ADDENDUM No. 2

ITB No. 4569 Wheeler Service Center PUD Non-Motorized Improvements - Phase 2

Plans; replace originally issued bid plan set noted as "WCWRC Comments" (sheets 1 thru 14) dated 03-09-18 with that issued for "Addendum 2" (sheets 1 thru 14) dated 03-28-19. Revisions are noted below.

Sheet 3 of 14

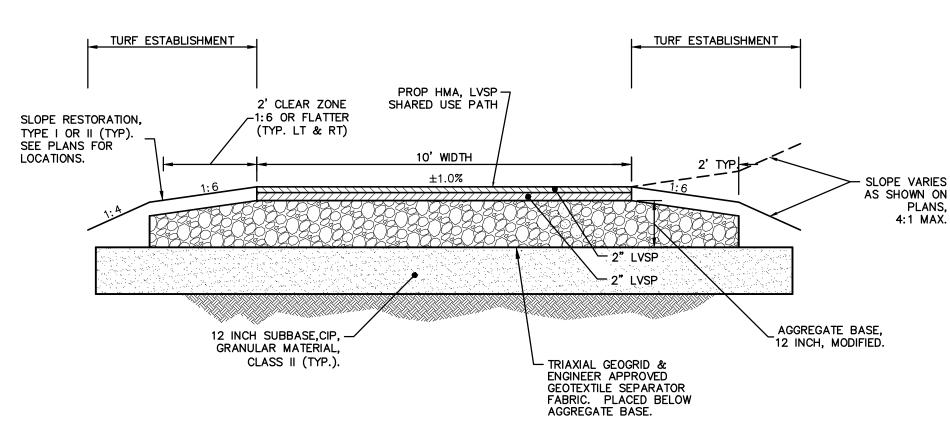
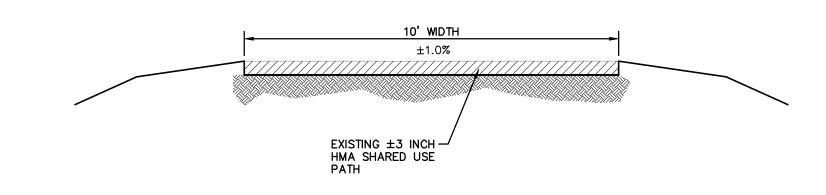
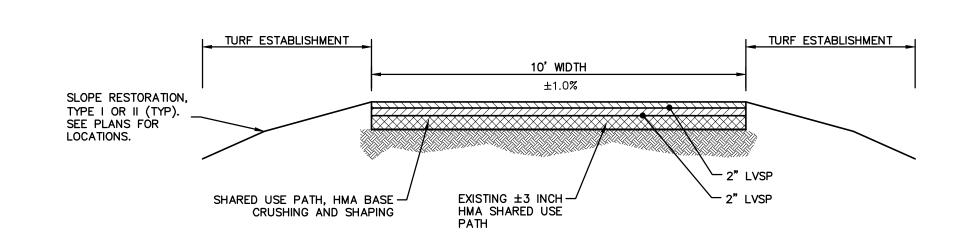
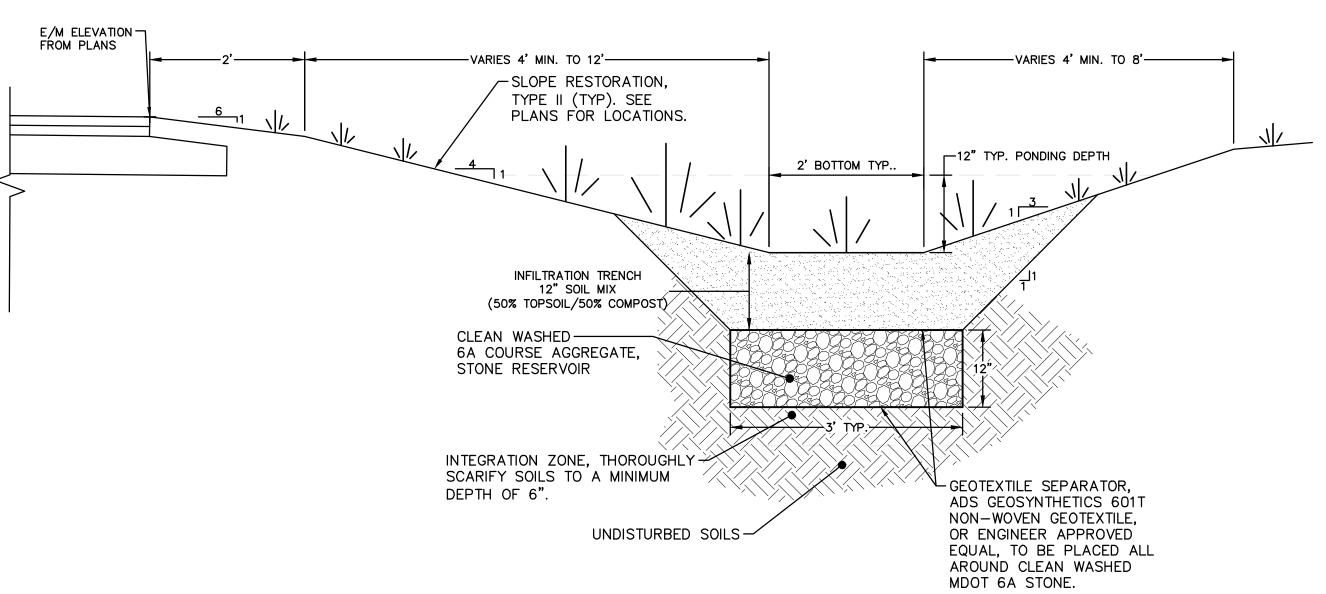
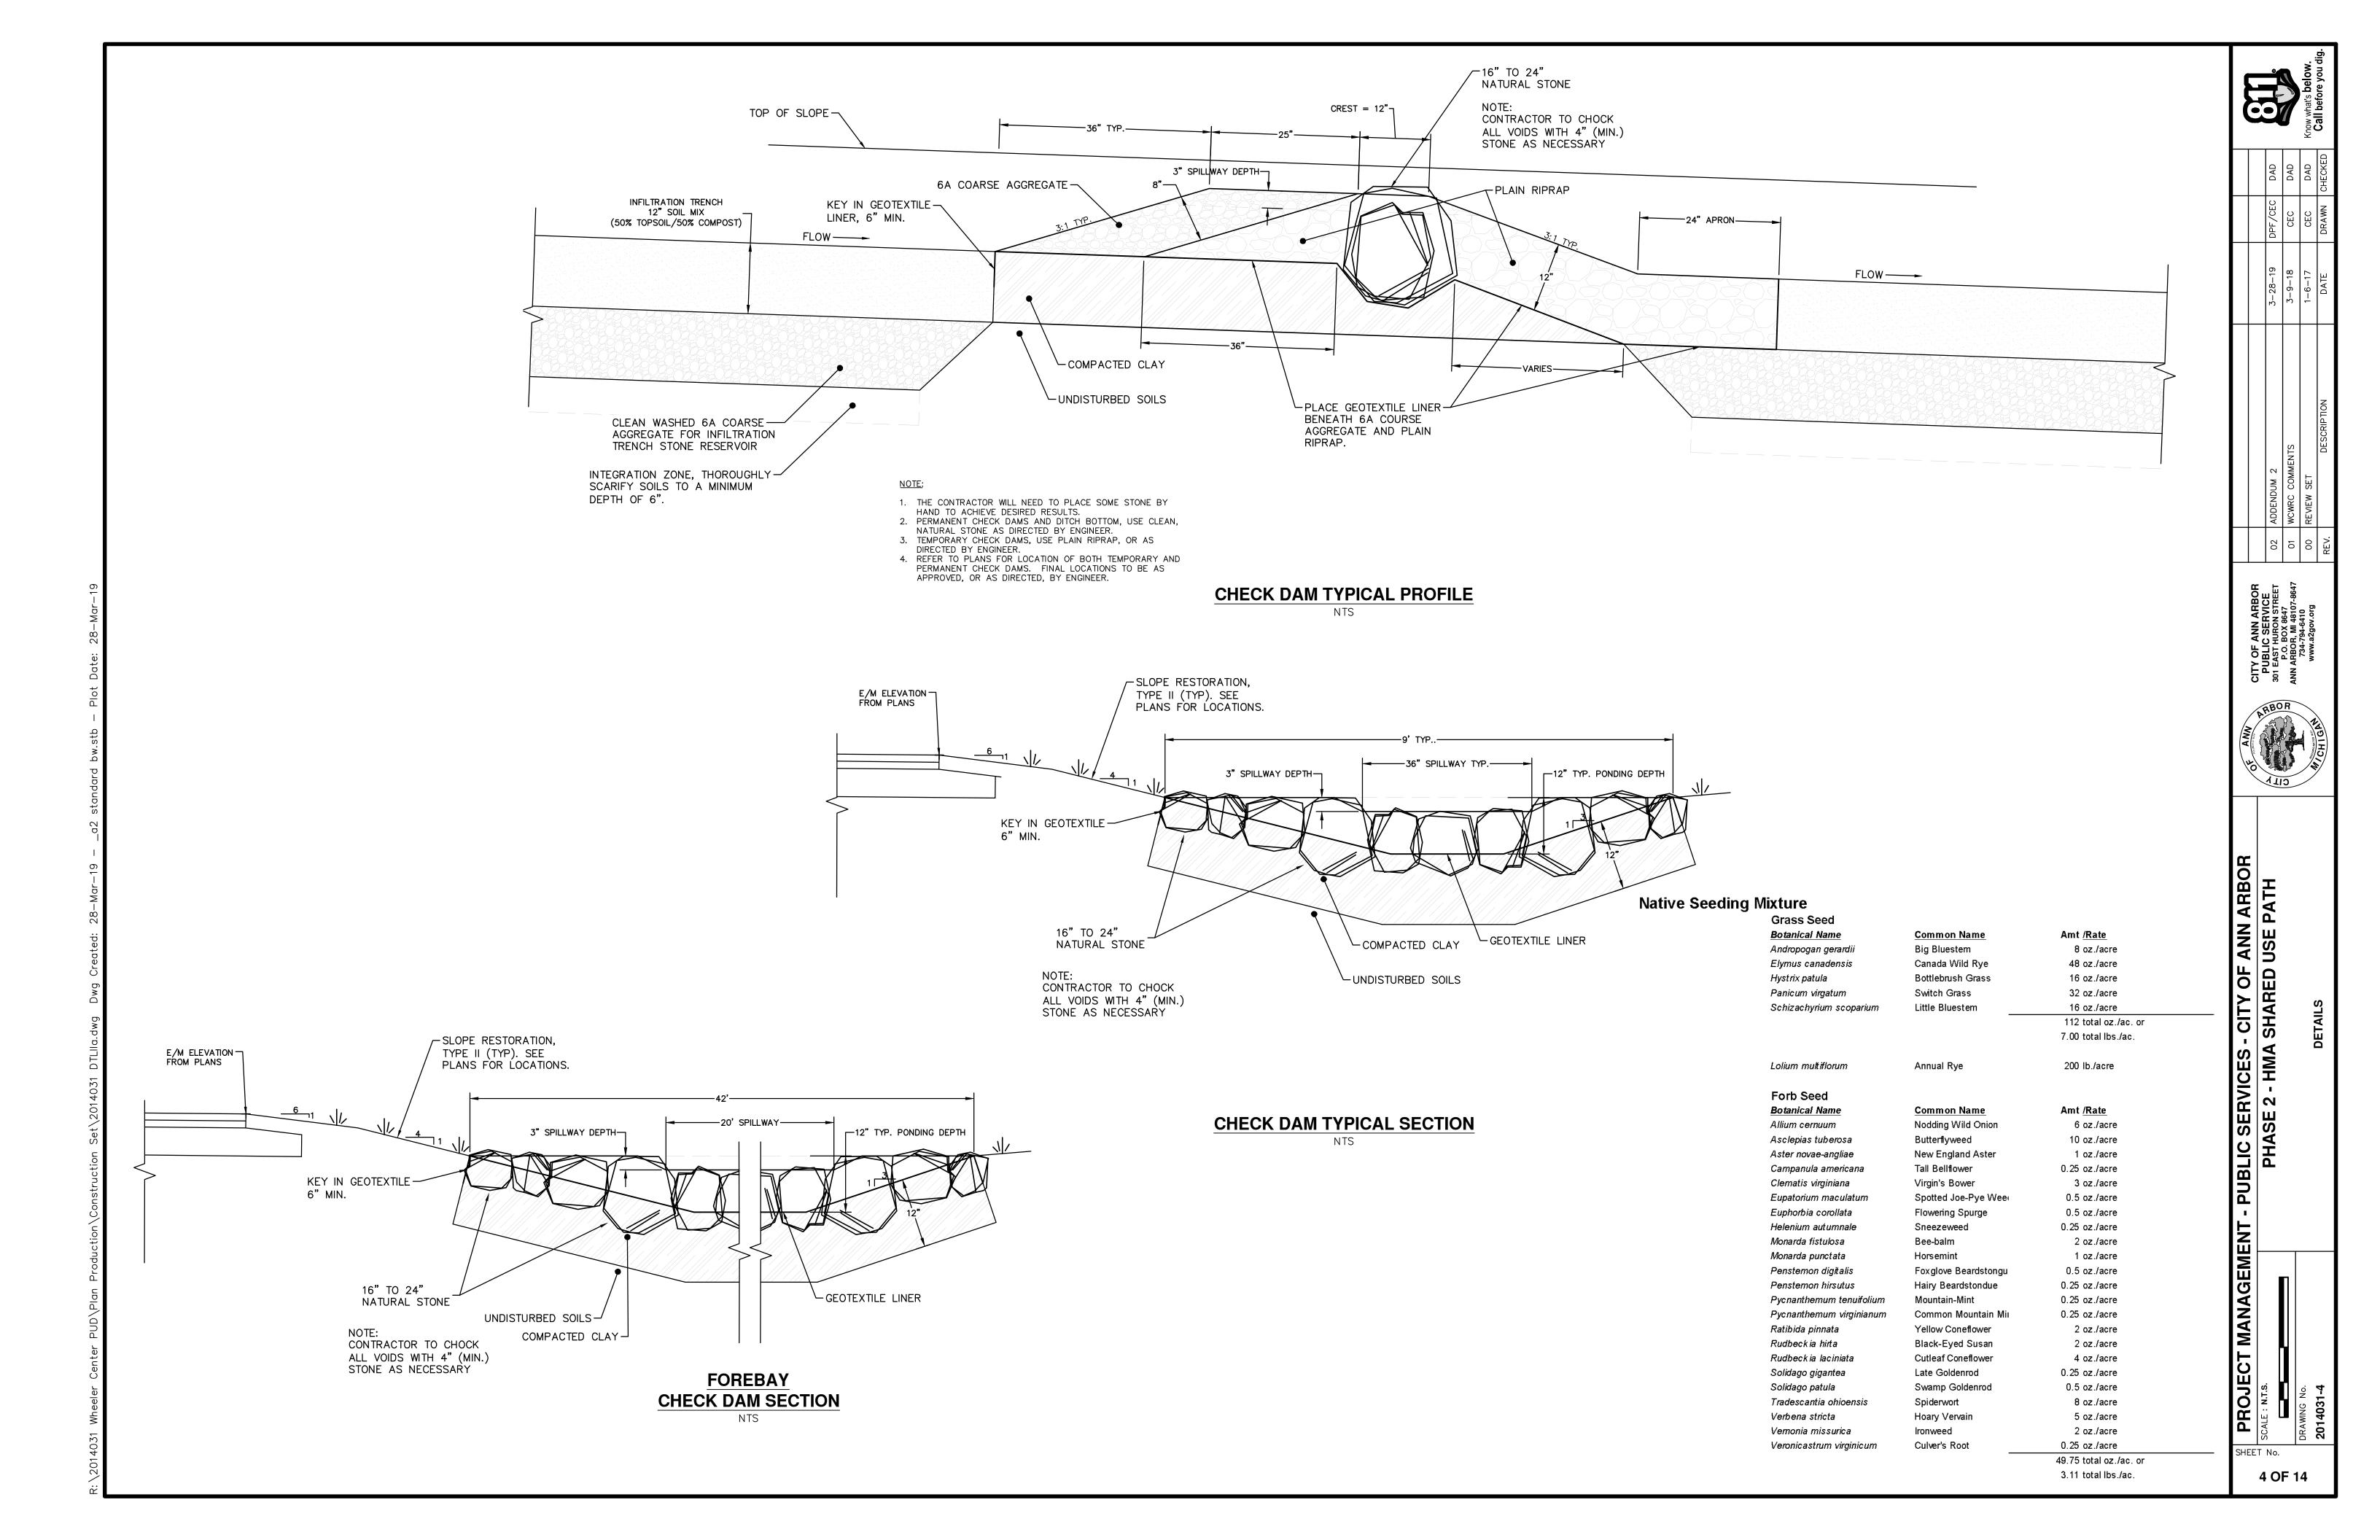
Revised/added Typical/Cross Sections for the existing/new HMA Shared Use Paths and Infiltration Trench to address inconsistencies with the specifications and clarify required work. Deleted Steel Pipe Bollard standard detail as it is no longer applicable. Revised Shared Use Path – HMA Application Estimate table.

9 OF 14

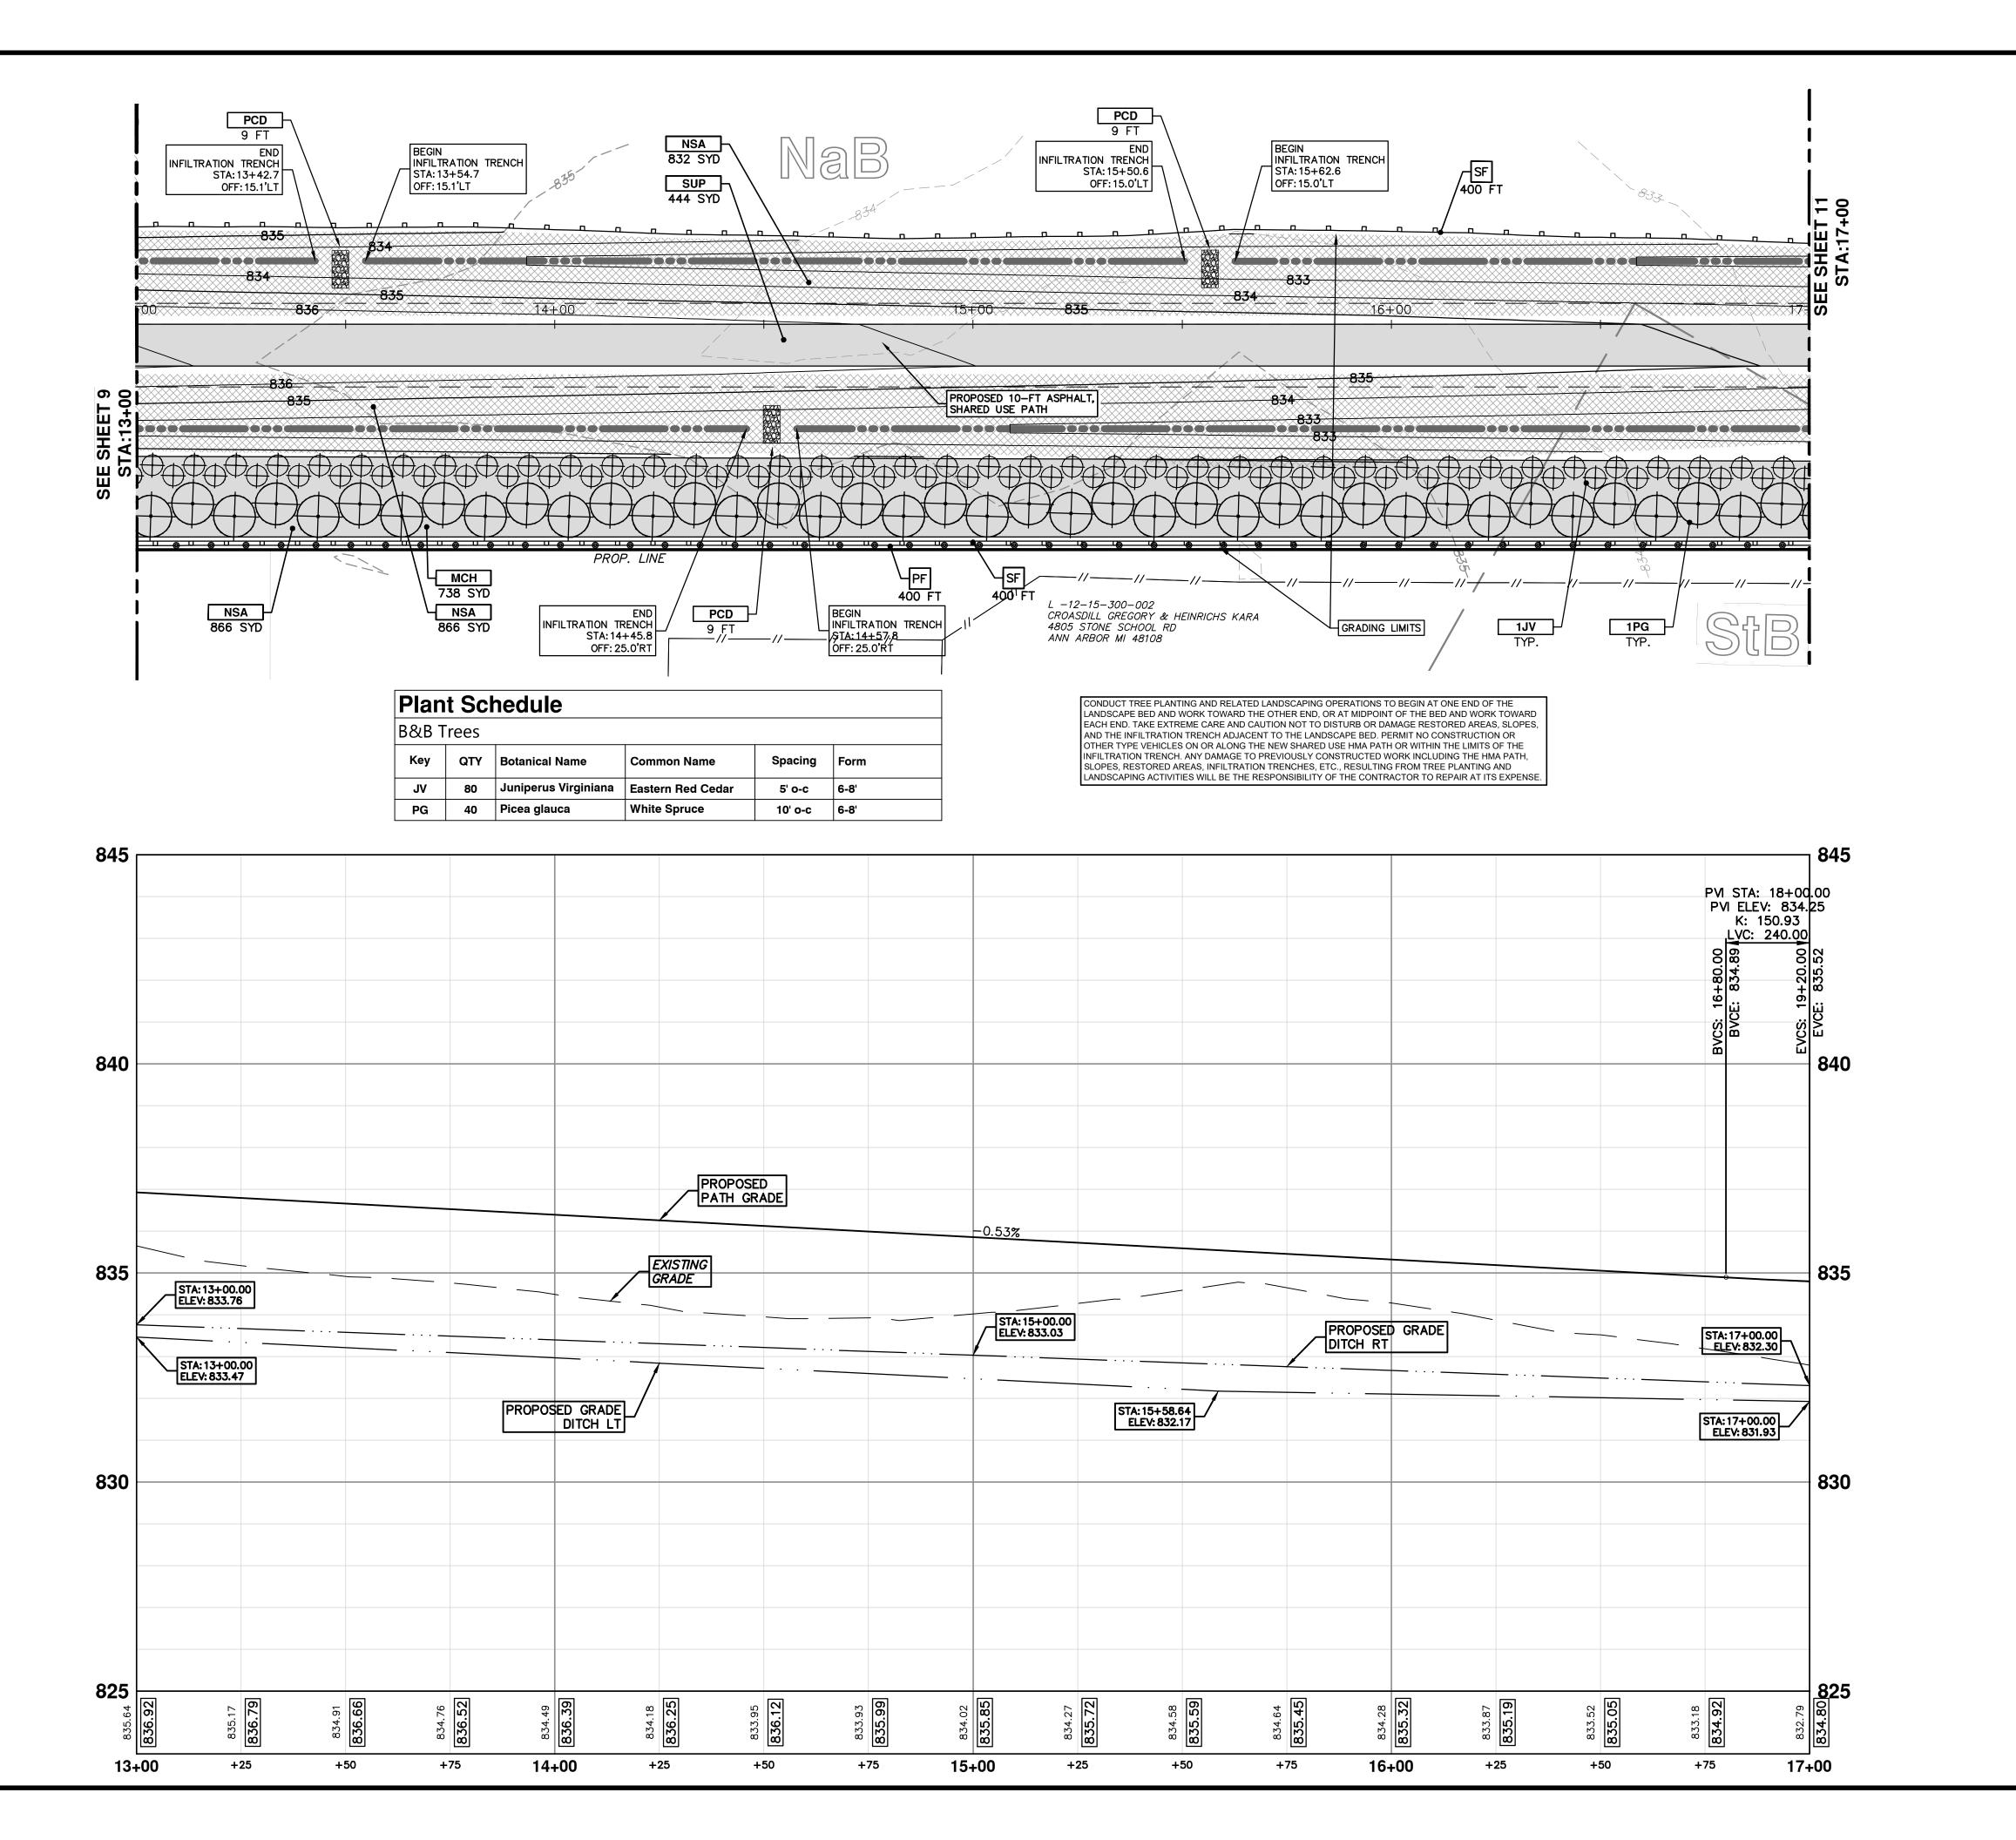
Removed majority of protective fencing along the northerly/easterly limits of the construction area and revised callouts and quantities related to this work. Revised Removal, Construction, and SESC Measures Keys. Added note related to tree planting/landscaping work.
